Board of Adjustments regular meeting

April 20, 2021 at 5:00p.m.

1. Request of Thomas Ladyman, on behalf of Idelisa Torres, for a variance to allow an existing screen enclosure to remain located 9.1 feet from the rear lot line, in lieu of the required rear setback of 10 feet and to allow 169 square feet of screen enclosure beyond the allowable area.

2. Request of Emiel McNish, on behalf of Ketan Pandya, for variances to allow the construction of a boathouse to extend approximately 70 feet into Lake Berry in lieu of the maximum permitted distance of 30 feet and allow an area of 960 square feet, in lieu of the maximum allowed area of 600 square feet.

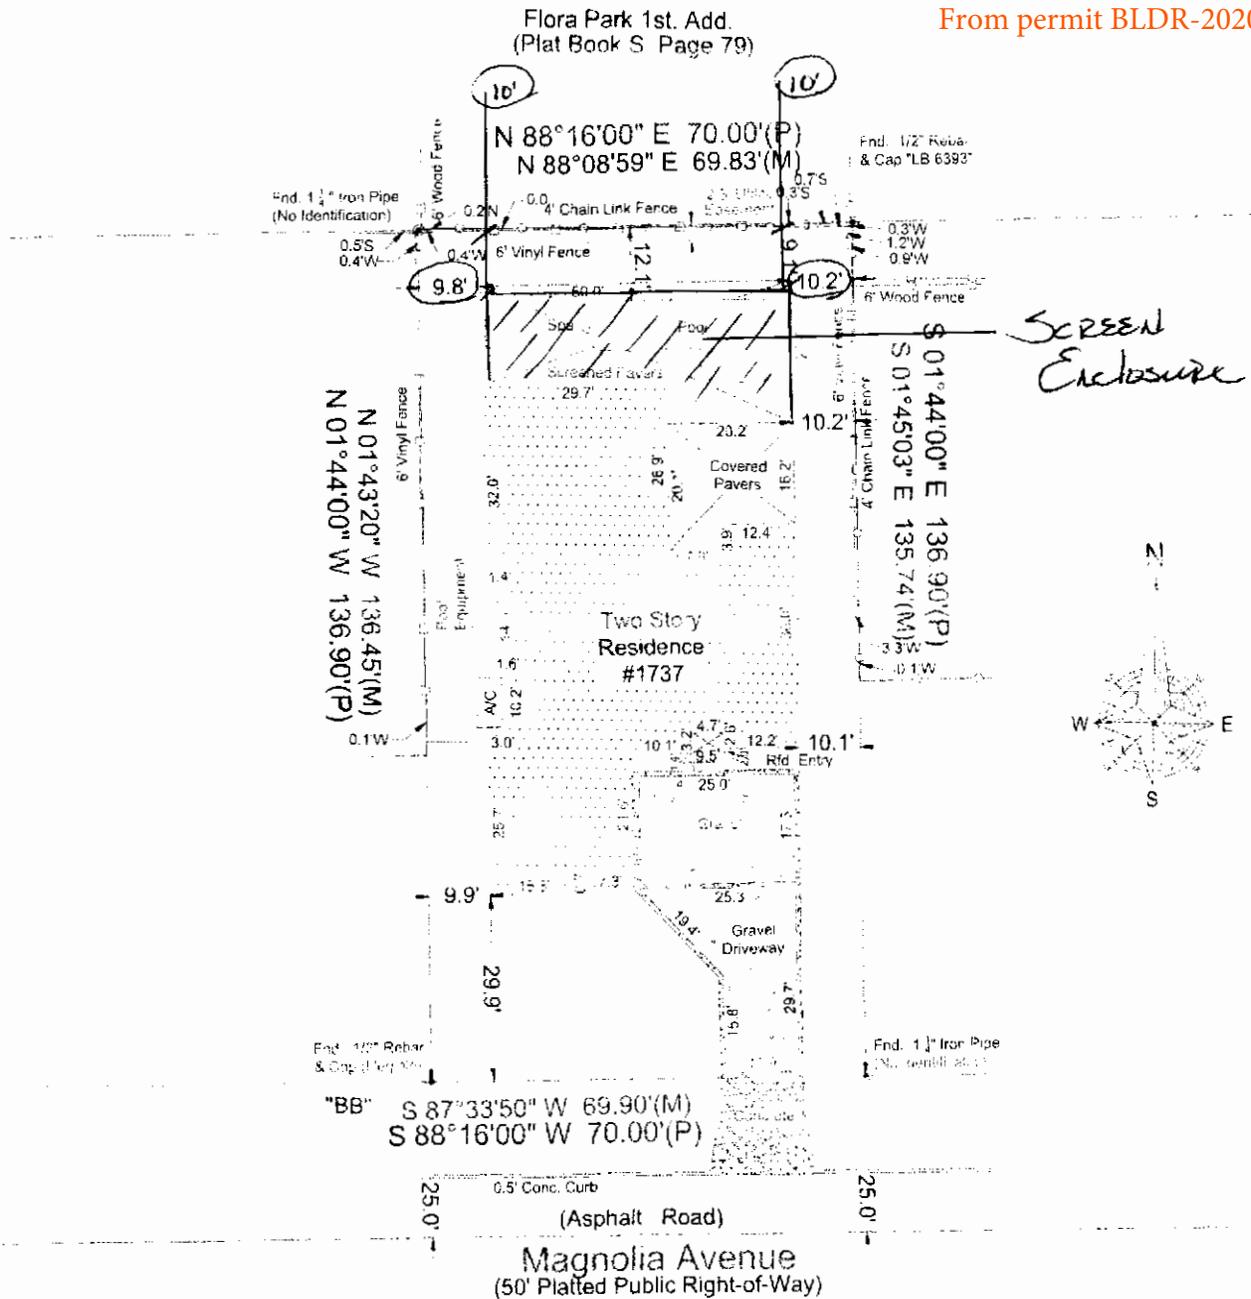
The rear setback to the enclosure is shown as 9.1 feet on one survey and 9.4 feet on another survey with each prepared by different state registered surveyors. When the original plans were submitted for a permit the indicated setback was 9 feet at the rear and the request for a permit was rejected.

The pool enclosure contractor proceeded with constructing the enclosure even though it was not compliant with the 10 foot rear setback or allowable area. With regard to remedial action that can be taken by the applicant if the Board is inclined to grant the setback variance, the placement of a tall landscape buffer across the rear of the enclosure with a material such as bamboo may be one solution to consider, however, modifications will need to be made to reduce the area of the enclosure by 168 square feet unless a variance is granted for this additional area.

violation of the rear setback requirement of 10 feet. No plan for a 9' rear setback was approved. The contractor submitted a revised plan with a conforming 10' rear setback and it has now been approved. The contractor must now correct the rear setback encroachment of the enclosure to comply with the 10 foot rear setback. Failure to do this within a timely manner will result in sending this code violation to the City's Code Compliance Board which has authority to impose a \$250/day fine until it is brought into compliance. In addition, the revised plan with the conforming rear setback does not exceed the allowable screen enclosure coverage.

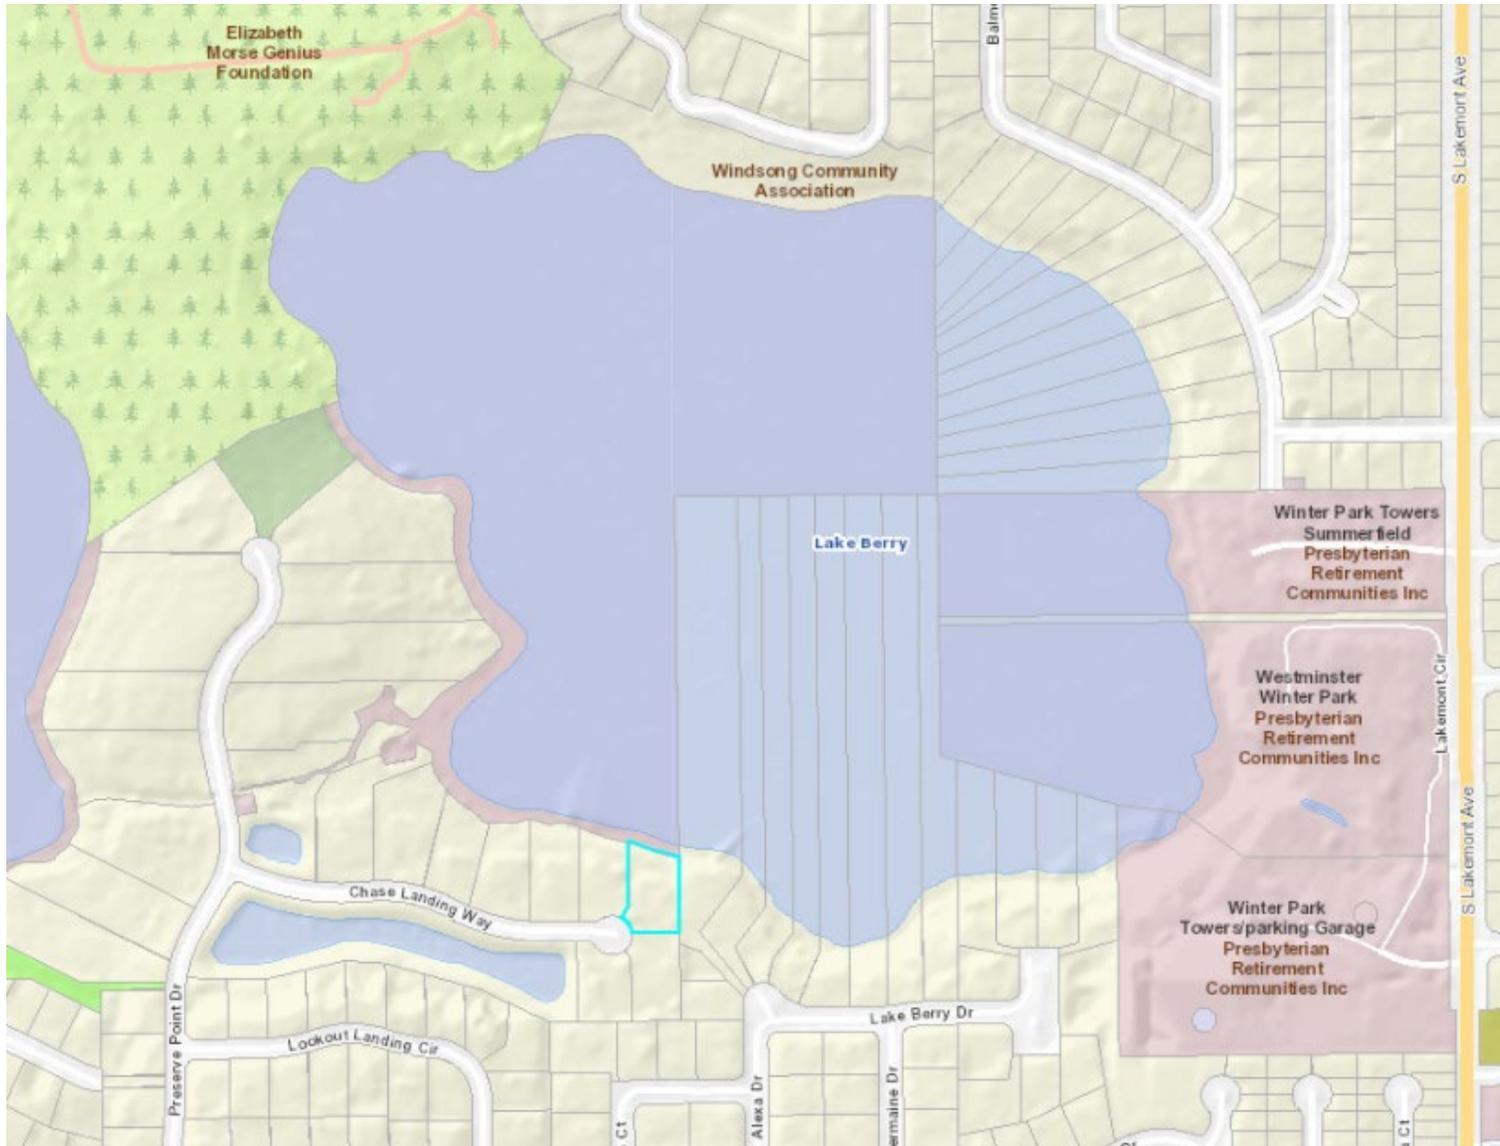
The applicant is requesting variances to allow a new boathouse to remain as partially built extending approximately 70 feet into Lake Berry from the ordinary high water line, whereas the maximum permitted distance is 30 feet. In addition, the request is to allow an overall area of 960 square feet, whereas the maximum allowed area is 600 square feet.

This boathouse received a building permit after revising the original plan that did not meet our typical boathouse criteria limiting the area to 600 square feet and 30 feet into a lake beyond the ordinary high water line. Construction proceeded and was later stopped due to a complaint from the neighboring property owner when it became apparent that the boathouse was not complying with the area and distance into the lake indicated on the approved plan. In addition, the neighbor pointed out that the boathouse will block his lake view and that it was his understanding that this boathouse was to be built on the opposite side of the lot rather than near the west side lot line.

With regard to having a definitive City Commission condition that all boathouses along the southwesterly shoreline of Lake Berry must be grouped next to each other along common lot lines with no side setback, I have not conclusively found a record of a boathouse grouping condition in the minutes of the Commission meeting in 1999 when the plat of the Windsong- Preserve Point Subdivision was approved for all lots along the south or western shore of Lake Berry. However, there was a condition approved that "the boathouses for Lot 8 & 9 be constructed immediately adjacent to each other (zero lot line)". An excerpt of those minutes is included in this report.

Current Survey

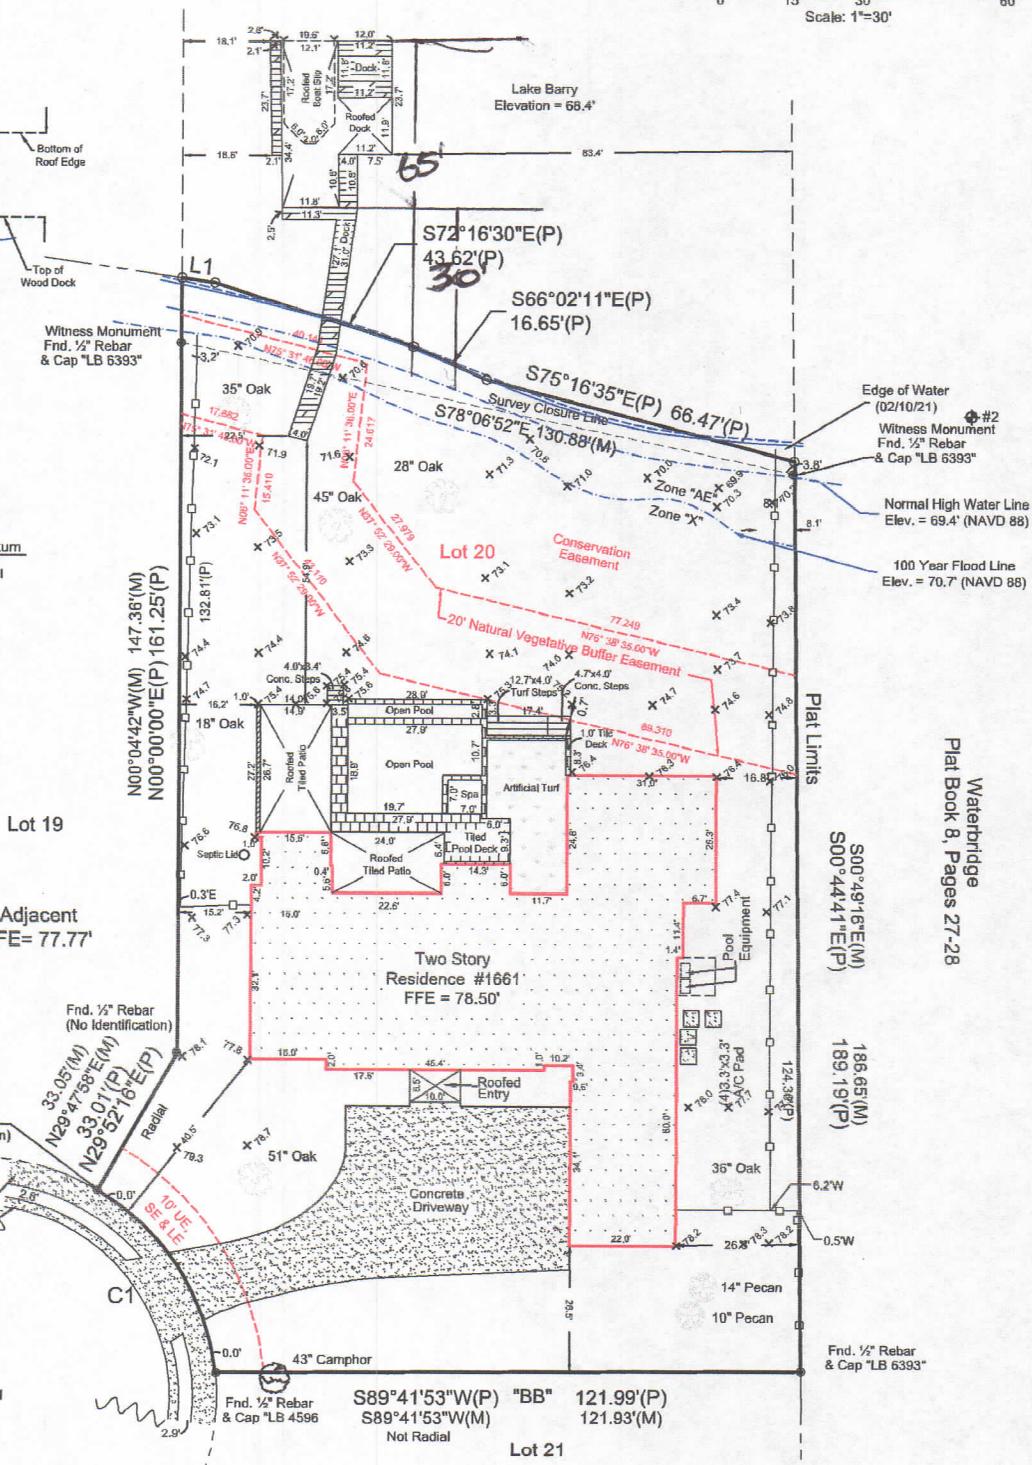
The dock built at 1661 Chase landing way permit# BLDR-2020-0345, was built exactly the same as the approved engineered plans stamped by the city but not the same area as what was on the approved survey. We went beyond the 30ft from the NHWE and now we are at 65ft beyond the NHWE.

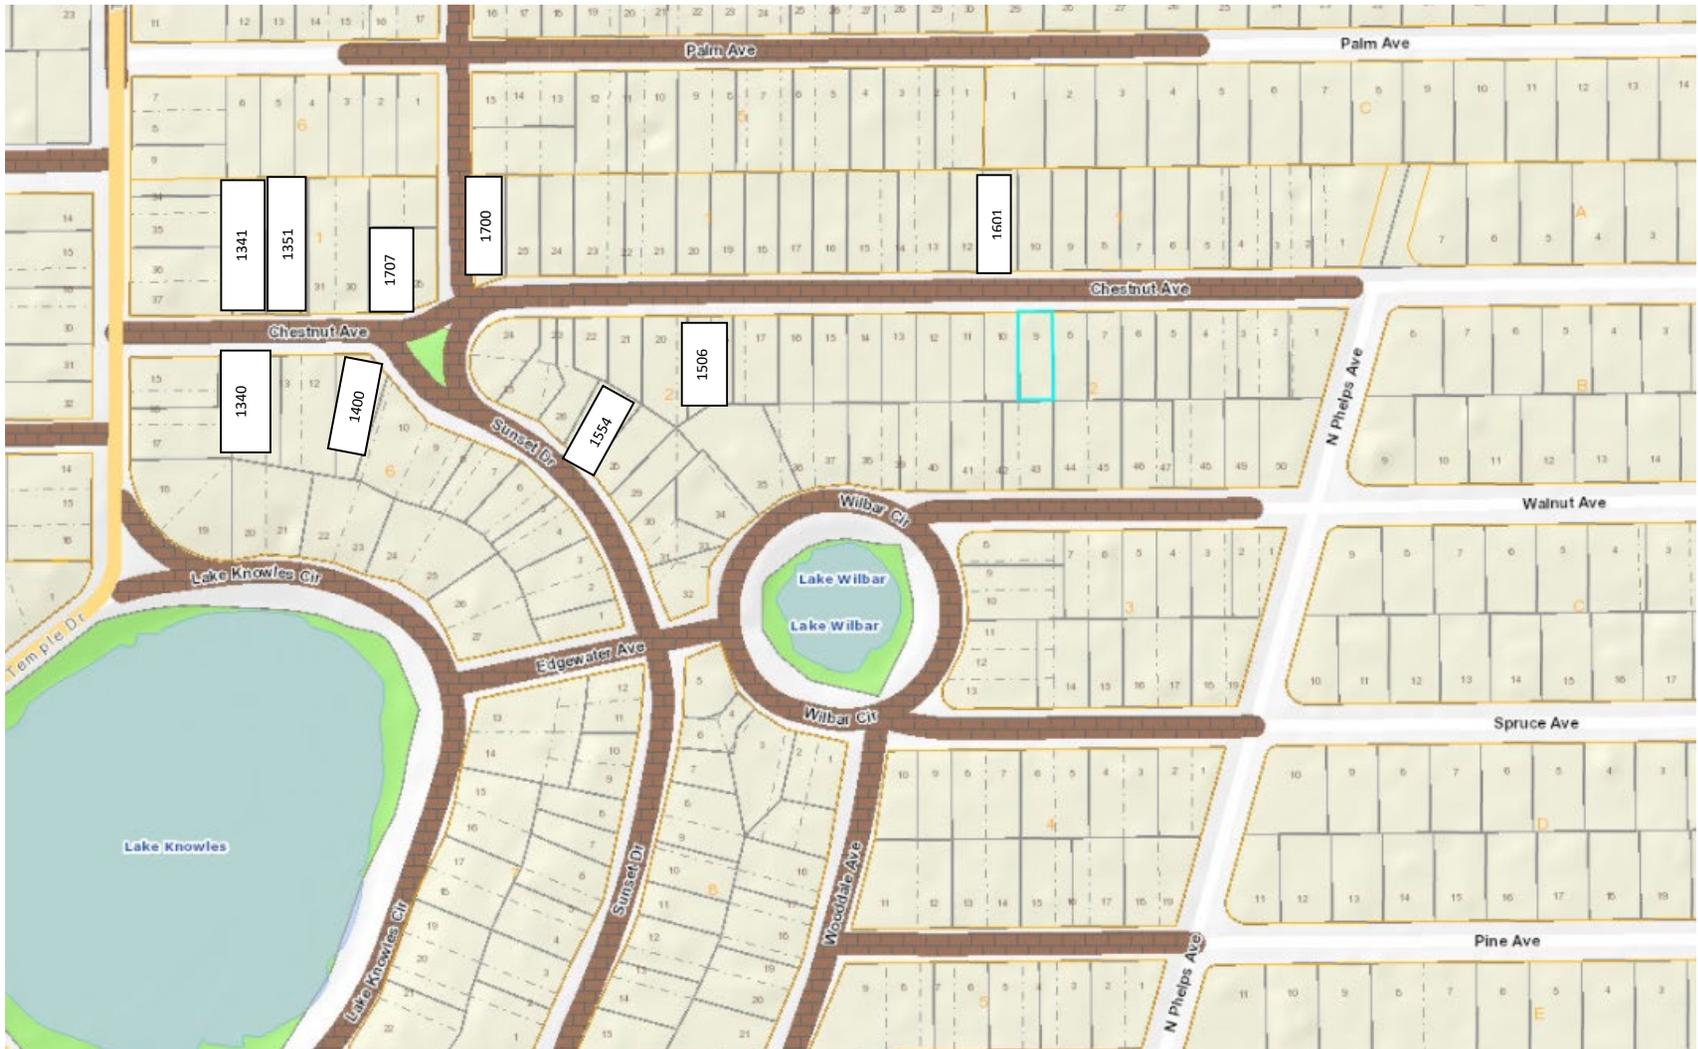
The applicant is requesting variances to allow construction of a second story addition to be located 7.3 feet from the side lot line, whereas the required setback is 12.5 feet, and without the required two feet of setback for a garage opening.

In order create usable living space (child's playroom) on the second floor of a two-story home in a location that is currently a second-floor balcony, the applicant seeks two variances from the larger second floor setback of 12.5 feet and from having a front facing garage articulation which is normally achieved with the garage opening stepped back behind the front wall of the home or projected out in ahead of the main front wall of the home.

The proposed design of this second-floor area includes a much larger glazed opening at the second-floor level and a new glass garage door on the lower level to match the architecture of the home.

The 2nd floor sits directly above the garage on the bearing walls. Architecturally, the upper walls would have to line up with the lower bearing walls in plane with one another. Owner would be open to potentially building an eyebrow that would be proud of the front elevation at the first floor level.
